STAFF REPORT
COMMUNITY DEVELOPMENT DEPARTMENT

HEARING DATE: 06/23/2026
TO: Mayor & City Council
FROM: Sonya Allen, Associate Planner
sallen@meridiancity.org
SUBJECT: Dayspring Subdivision No. 3
FP-2026-0007
LOCATION: Generally located 1/4 mile south of W. Ustick Rd., midway between N. Black Cat Rd. & N. McDermott Rd., in the north 1/2 of Section 4, T.3N., R.1W.

Final plat consisting of 57 buildable lots and 8 common lots on 17.36 acres of land in the R-4 and R-8 zoning districts for the third phase of Dayspring Subdivision.

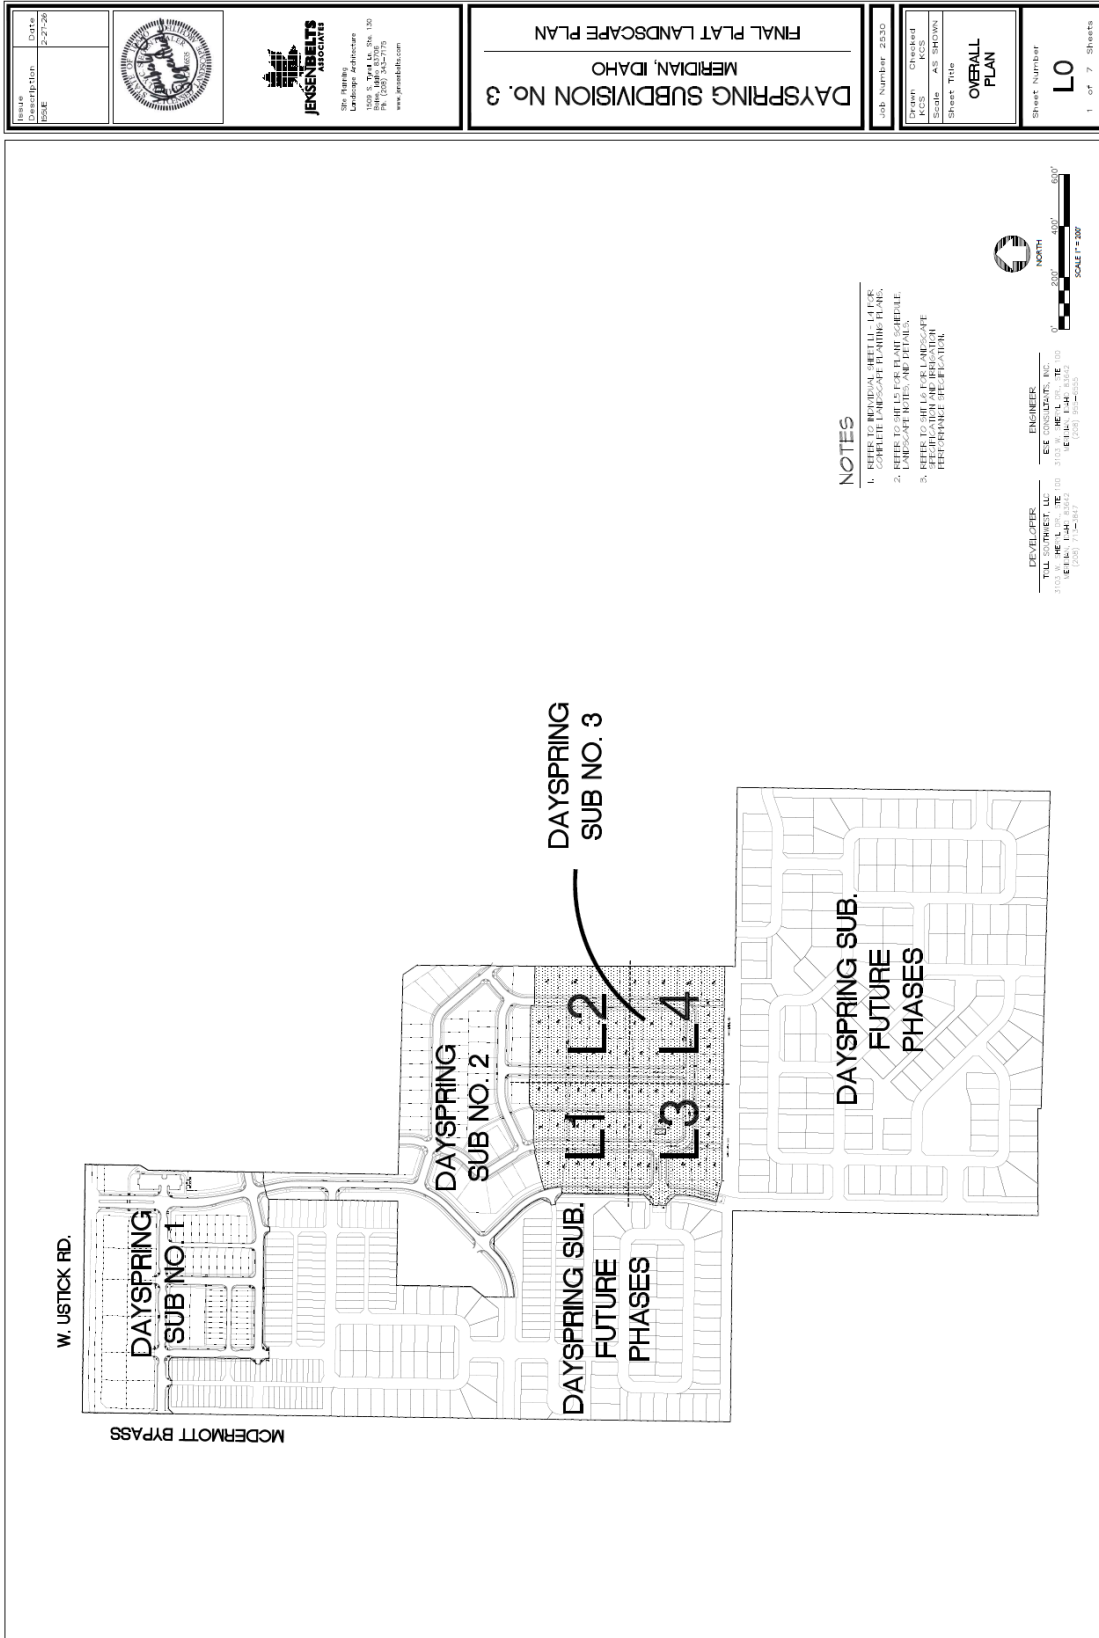
3. Prior to submittal for the City Engineer's signature, have the Certificate of Owners and the accompanying acknowledgement signed and notarized.
4. The final plat prepared by Clinton W. Hansen, Land Solutions Land Surveying and Consulting, dated: 3/5/2026, included in Section V.B shall be revised as follows:

- i. Include the Book and Page numbers for Dayspring Subdivision No. 2.
 - ii. Legend: Include the recorded instrument number of the ACHD permanent easement.

- iii. Include the recorded instrument number of the ACHD drainage easement.
 - iv. Include the recorded instrument number of the City of Meridian sewer easement.

- v. Note #9: Include the recorded instrument number for the development agreement (i.e. #2026-007562).
 - vi. Note #11: Include the recorded instrument number of the ACHD temporary license agreement.

A copy of the revised plat shall be submitted with the final plat mylar signature application.

FINAL PLAT LANDSCAPE PLAN

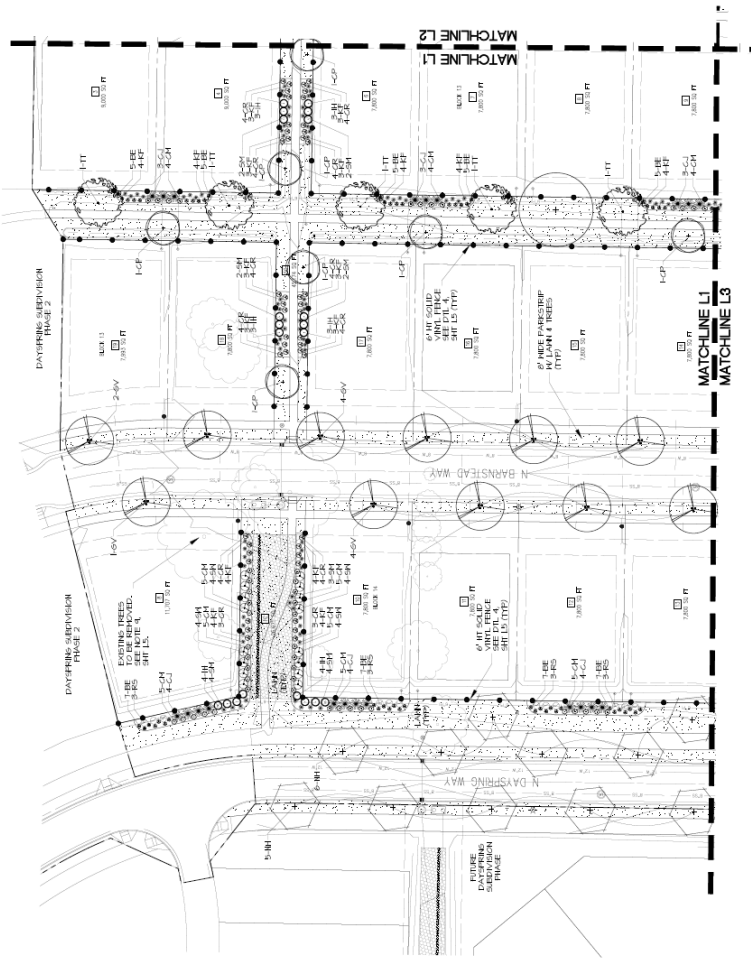
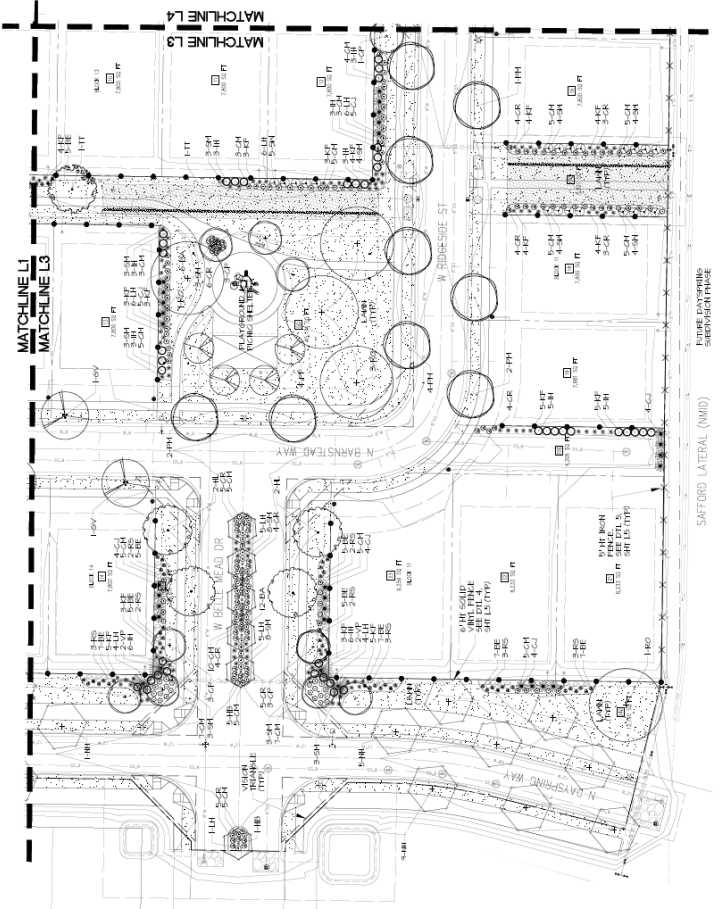
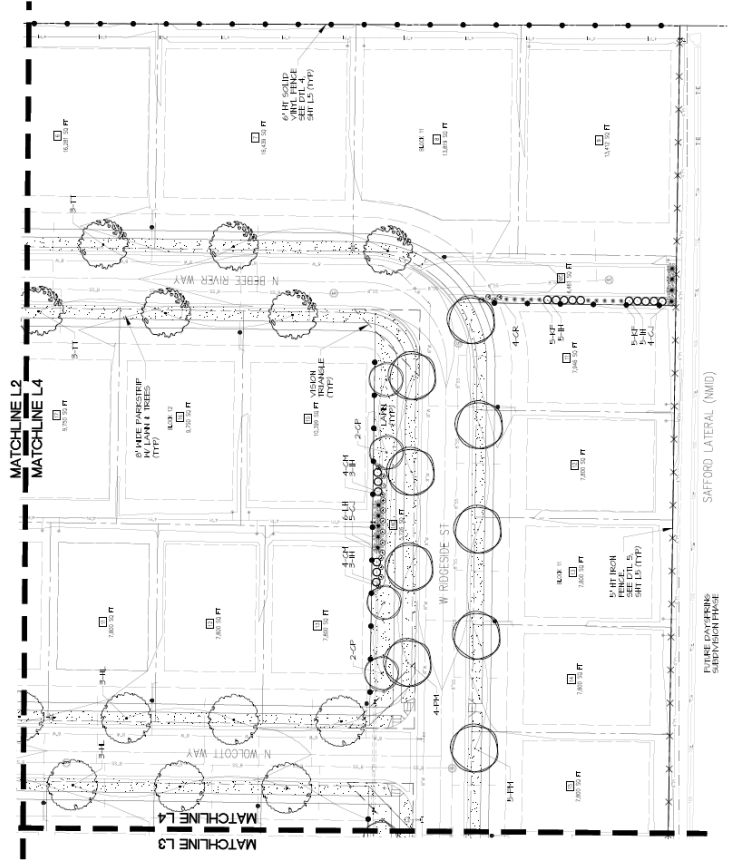
5. The landscape plan prepared by Jensen Belts Associates, dated 2/27/2026, included in Section V.C, shall be revised as follows:
 - i. Depict minimum 5-foot wide landscape strips along each side of all pathways with landscaping per the standards in UDC 11-3B-12C, which require a *mix* of trees, shrubs, lawn and/or other vegetative groundcover.

- ii. Include the required vs. proposed number of trees in common open space areas in the Landscape Calculations table that demonstrate compliance with the standards listed in UDC 11-3G-5B.3.

- iii. Include the required vs. proposed number of street trees, tree classification, percentage of lawn, and width of required (i.e. 20') vs. provided street buffer in the Landscape Calculations table for the street buffer along N. Dayspring Way that demonstrates compliance with the standards listed in UDC 11-3B-7C.3.

- iv. Include the required vs. proposed number of trees along pathways, including linear feet of pathways, in the Landscape Calculations table that demonstrates compliance with the standards listed in UDC 11-3B-12C.

A copy of the revised landscape plan shall be submitted with the final plat mylar signature application.

LOT 20C BLOCK 11 COMMON DRIVE

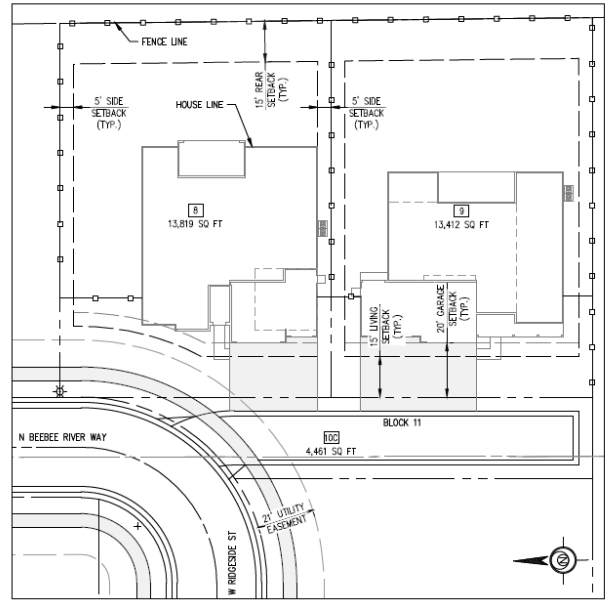
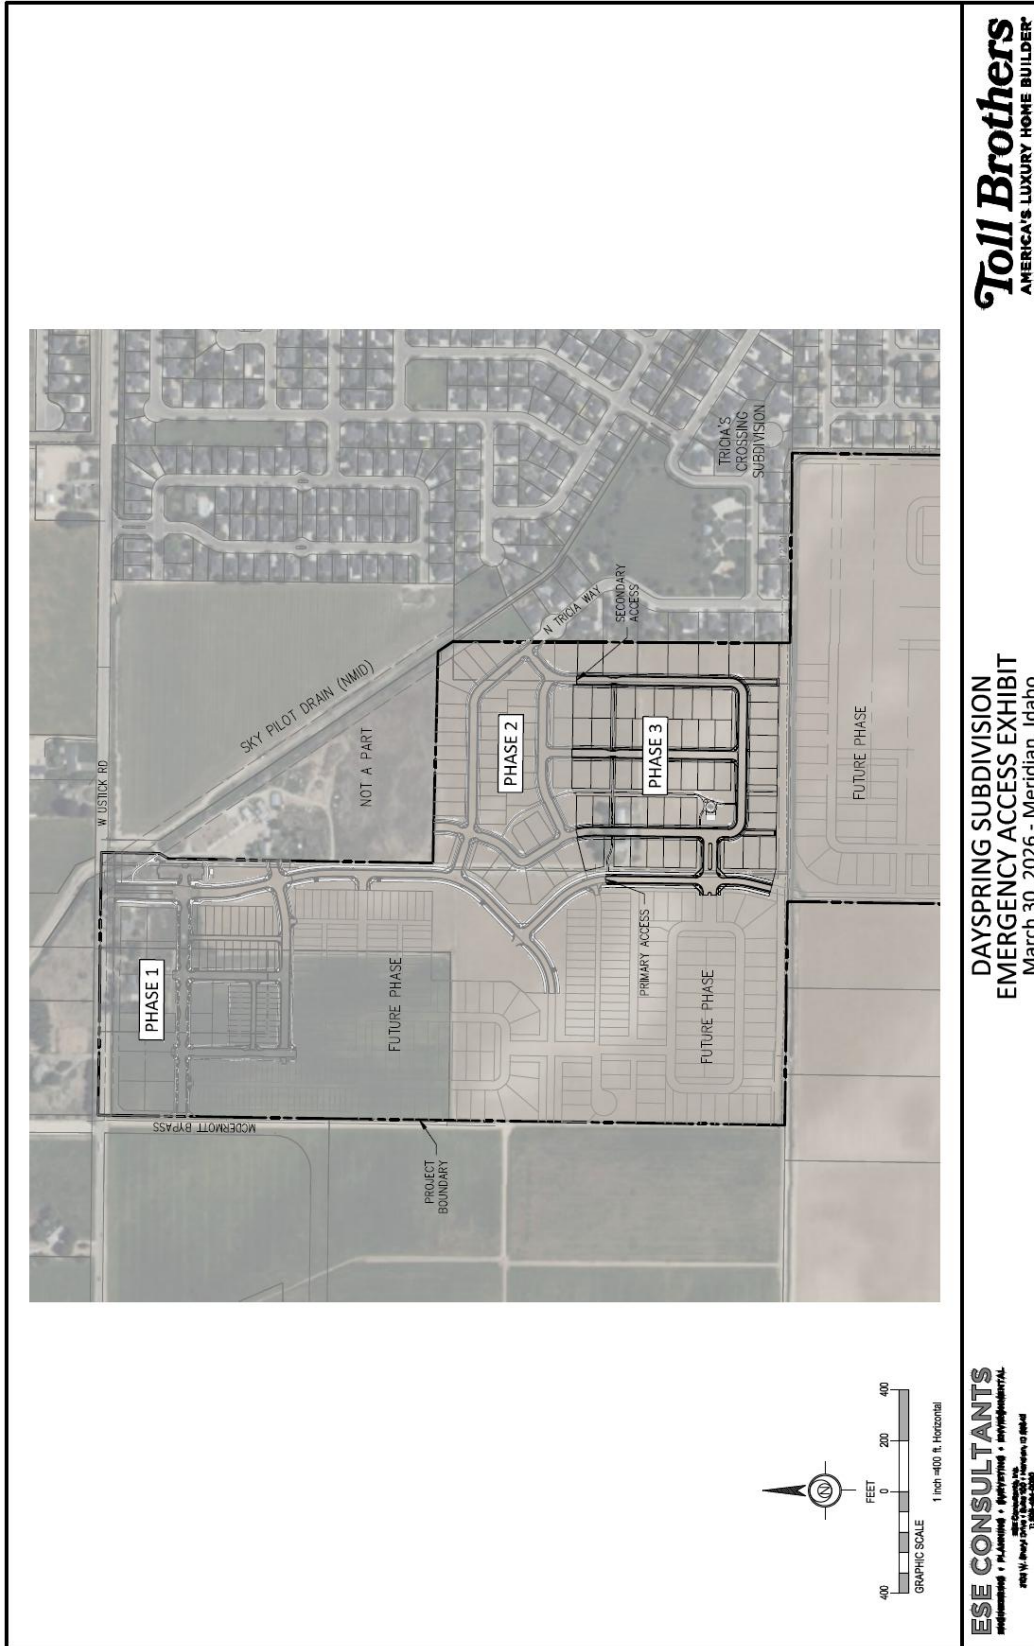
4. Do not put Sewer mains in common driveways. Run Sewer services directly to main for common driveways with 4 or less lots
